Re: **Joliet Junior College, Illinois Community College District No. 525
Master Facilities Plan Phase 1, Campus Center Building Work, Bid Release 12
1215 Houbolt Road, Joliet, Illinois 60431**

Subject: **Supplement No. 1**

**BIDDING AND CONTRACT REQUIREMENTS
ADDENDUM NUMBER 1**

**JOLIET JUNIOR COLLEGE – BID RELEASE 12
CAMPUS CENTER
Interior Architecture**
Architect's Project Number: 208069.00

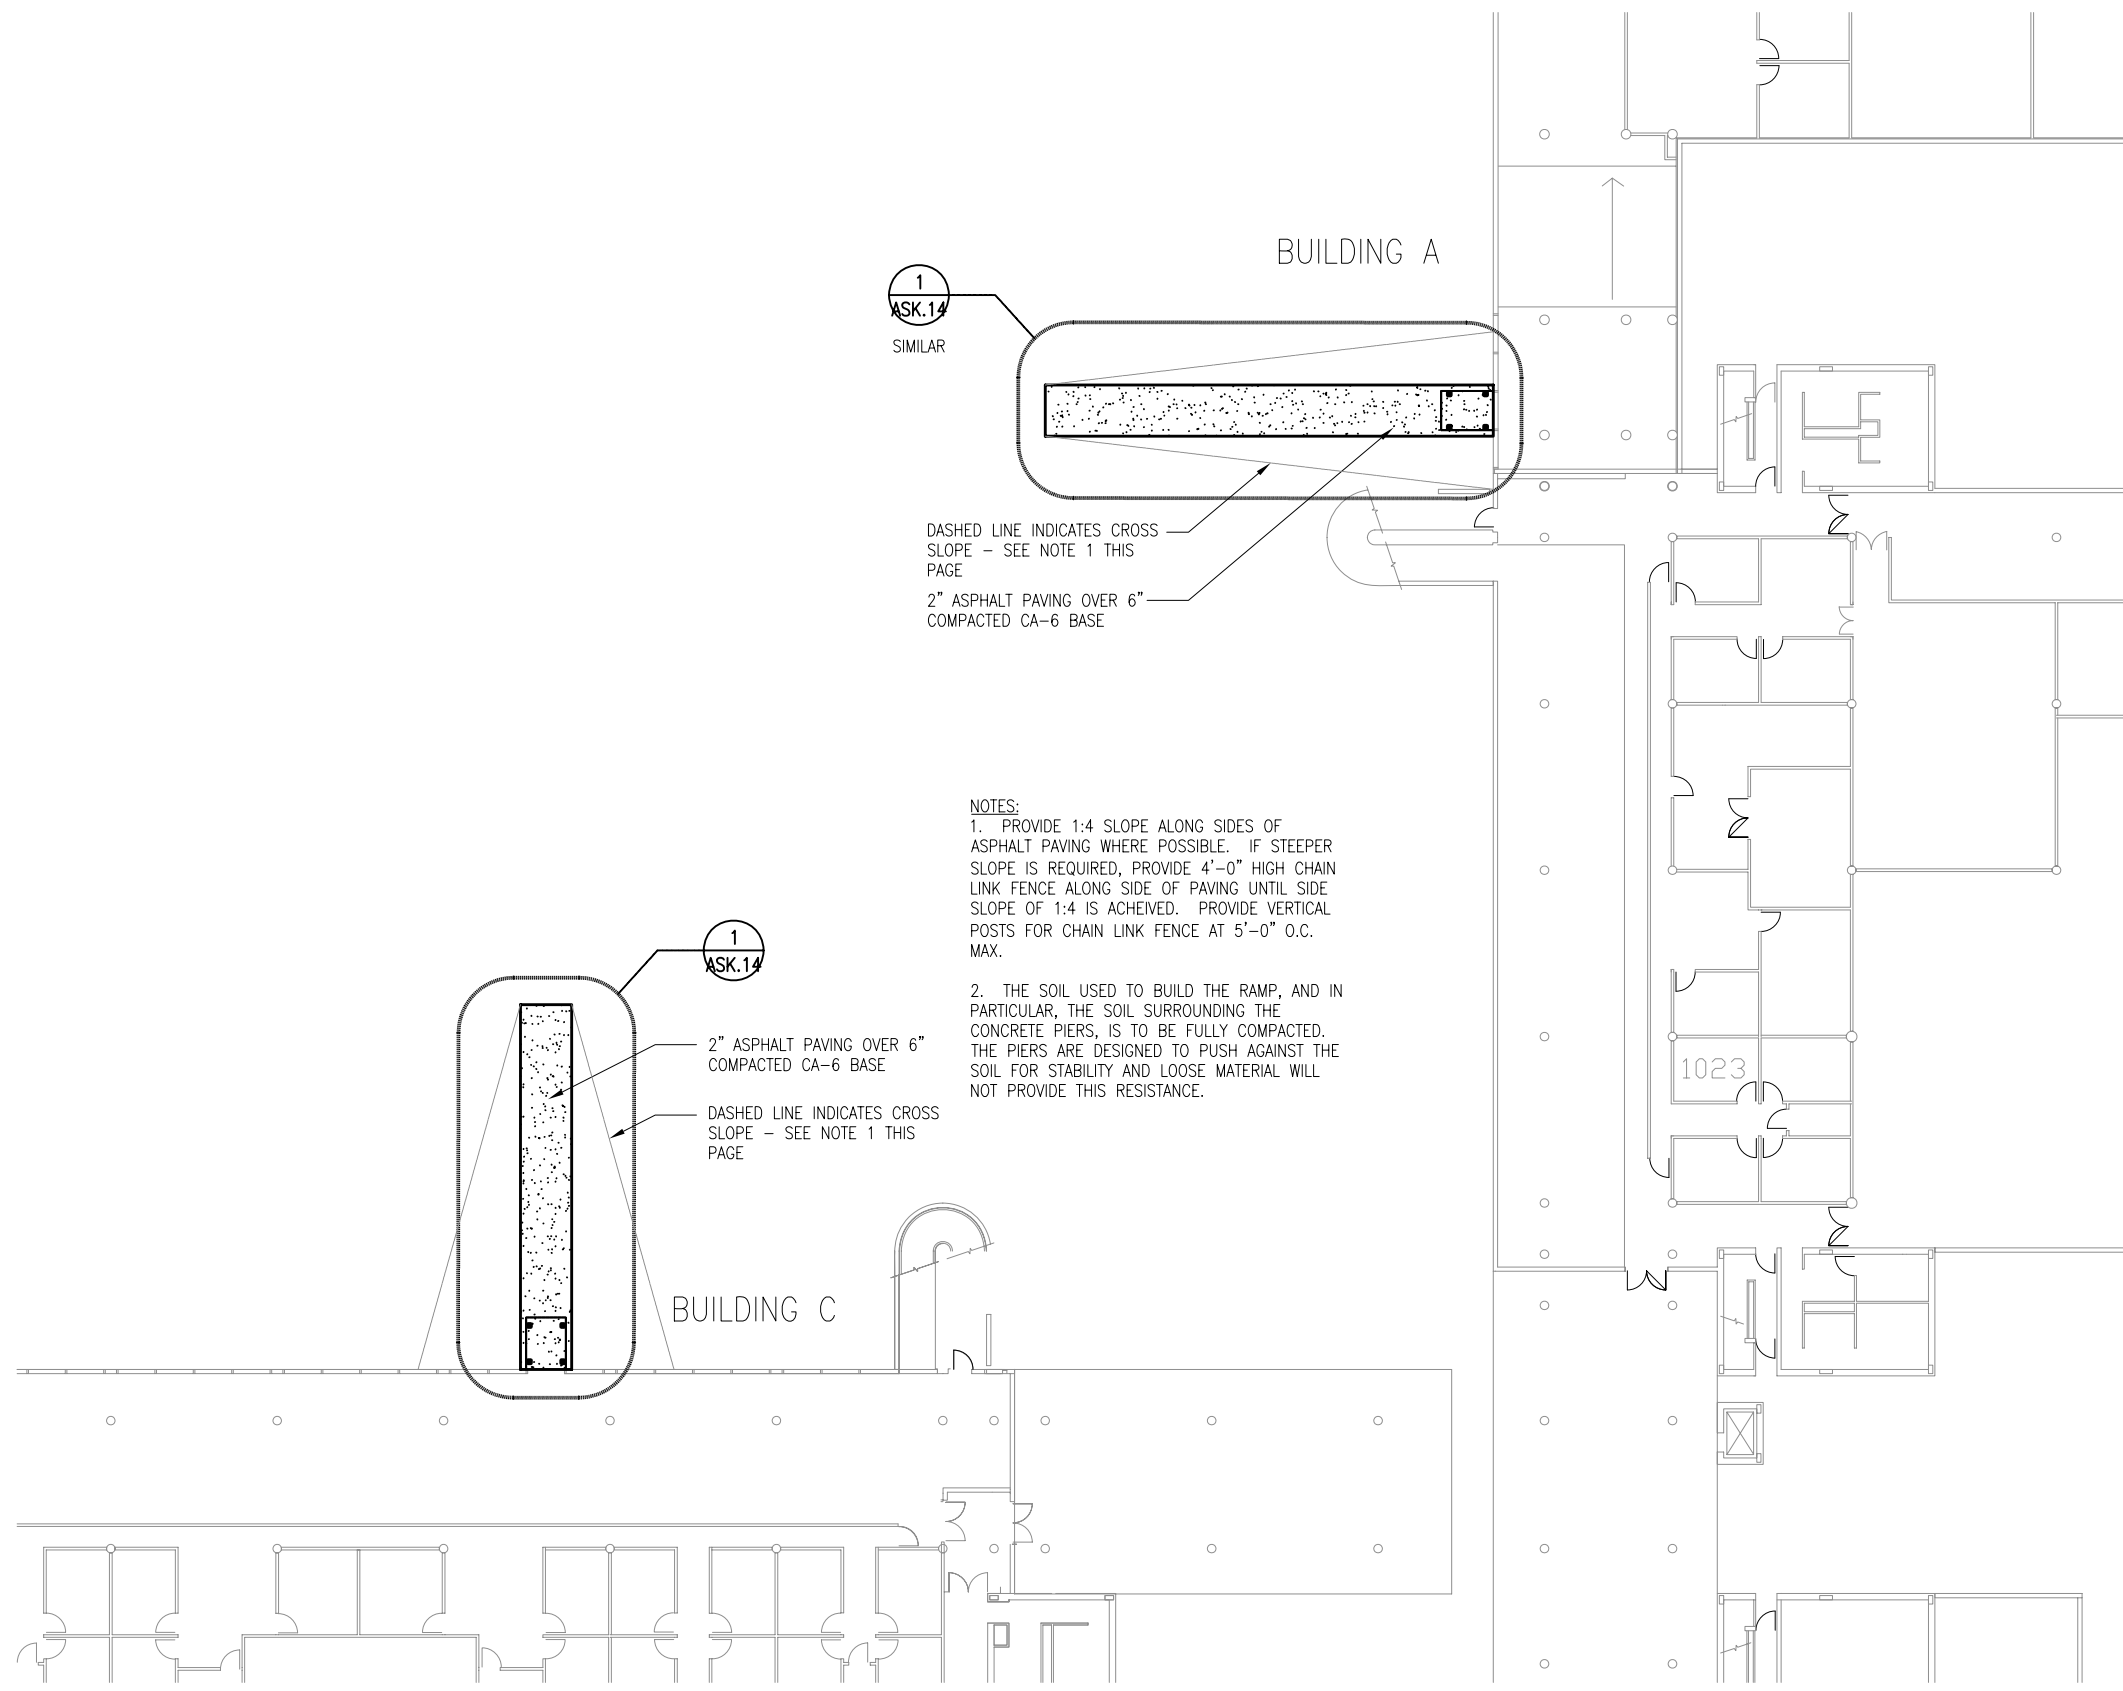
temporary interior vestibules and exterior canopies. The exterior canopies are shown in ASK 13-ASK-17, which was added in Addendum #1. The general trade contractor shall include in the base bid the cost to tear down and haul off-site both exterior canopies and associated footings as well as the interior vestibules and hollow metal doors and frames. Each entrance door has an automatic door operator, so the base bid is to include the cost to remove the automatic operator and terminating the power that runs to these operators. The work to re-install the curtainwall and glazing at each of these two openings is not to be included in the General Trades contractor's scope of work. The demolition and removal of the canopy and vestibules will occur at the end of the project, which will be at approximately May 2011."

- r) Drawing S3.01: REVISE Details 12 and 18 as shown on attached sketches SSK-51 and SSK-47 respectively.
- s) Sketches ASK-13 thru ASK-17: ADD these sketches in their entirety attached hereto.
